V2500-A5 SERIES PROPULSION SYSTEM NON-MODIFICATION SERVICE BULLETIN

This document transmits the Revision 1 of Non-Modification Service Bulletin V2500-ENG-73-0221.

V2500-ENG-73-0221

NON-MODIFICATION SERVICE BULLETIN - ENGINE - EPR MODIFIER CLASS CORRECTION DUE TO TEST CELL CALIBRATION SHIFT

Figure 1: DEP Jumper wire Contact Hole Locations

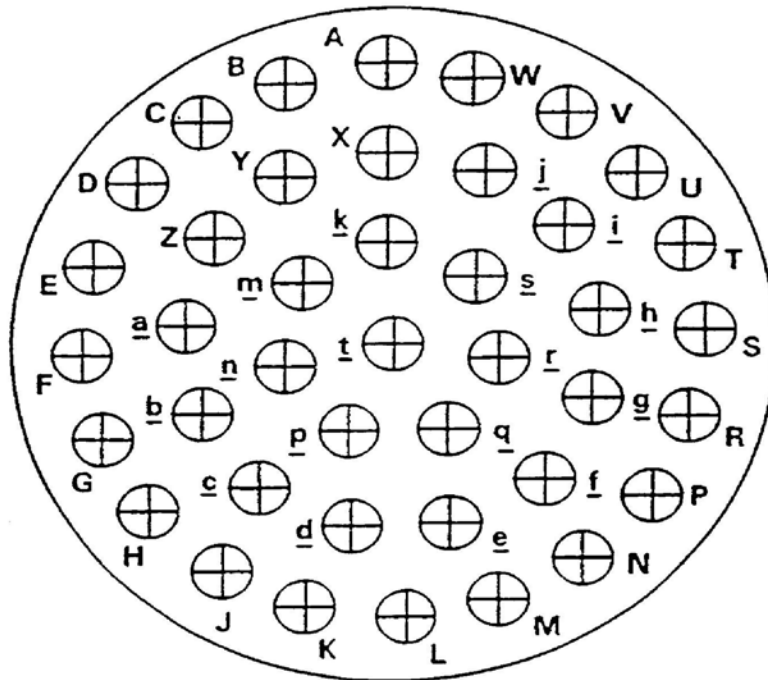
(2) Make two photo copies of Figure 1 of this Service Bulletin, DEP Contact Hole Locations.

(3) Mark all existing jumper connections from the DEP connectors on one copy of the figure and label it 'Pre SB ENG-73-0221 Pin Connectors'.

(4) Find the existing EPR Modifier Class marked on the DEP and confirm that the Data Entry Plug wiring agrees with the jumpers according to Table 3.

- (6) Mark the jumper locations for the new EPR Modifier Class (see Table 3) on the second copy of the Contact Hole Location Sheet. Mark all other existing jumper locations that are not affected by the EPR Modifier Class Change. Label this copy 'Post SB ENG-73-0221 Pin Connectors'.

- (7) Remove the jumpers to change from the existing EPR Modifier Class and install the jumpers needed for the new EPR Modifier Class according to the procedures in AMM 73-22-35-801.

Table 3: DEP Pin Selection for EPR Modifier Classes

Figure 2: Location of the Engine Identification Plate (Ref. IPC Sequence No. 72-32-85, Figure 3, Item 120)

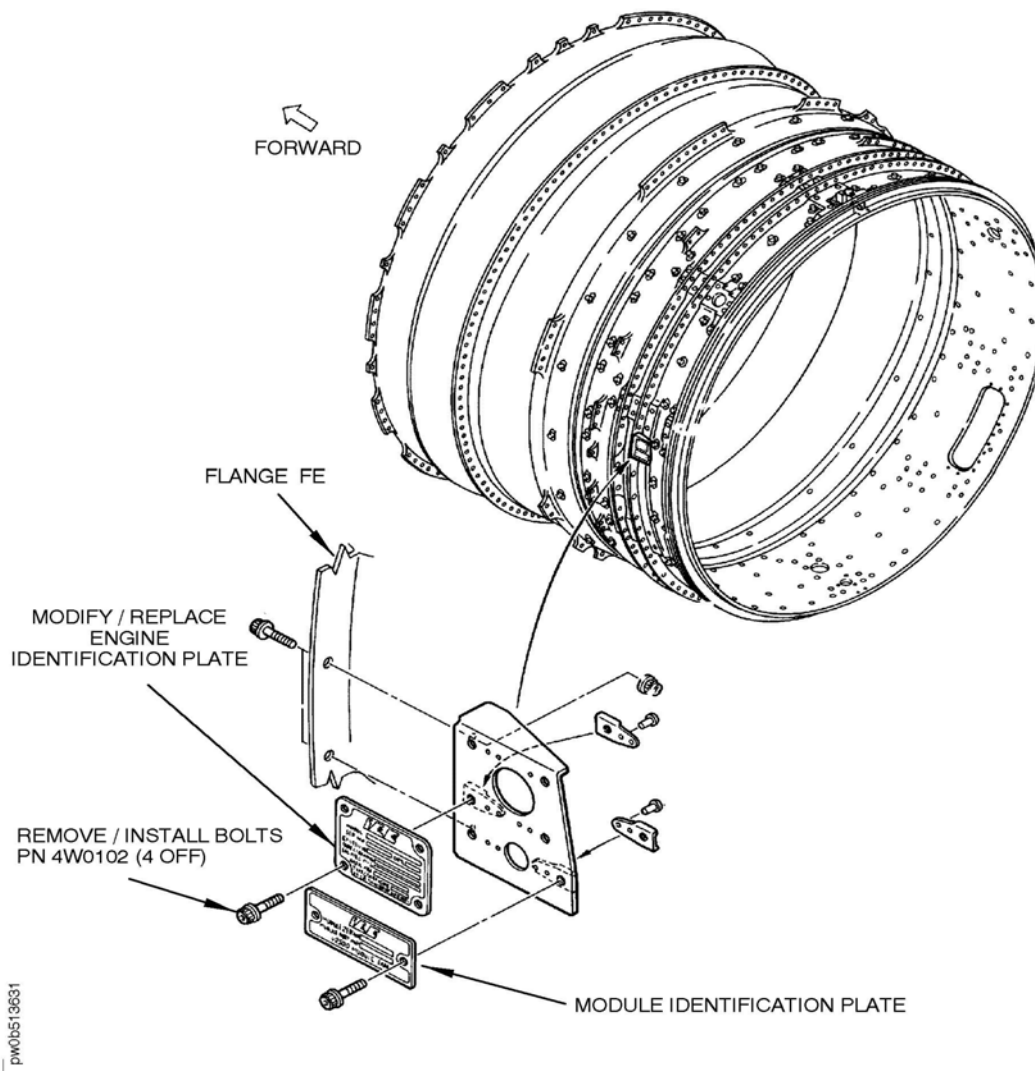
- (1) Remove the four bolts that secure the old Engine Identification Plate to the bracket located on the fan case at the 9 o'clock position. See Figure 2.

- (2) Install the new Engine Identification Plate to the bracket located on the fan case at the 9 o'clock position with part number 4W0102 Bolts (4 off). See Figure 2

- (3) Torque bolts between 32-36 lbf·in (3,61-4,07Nm).
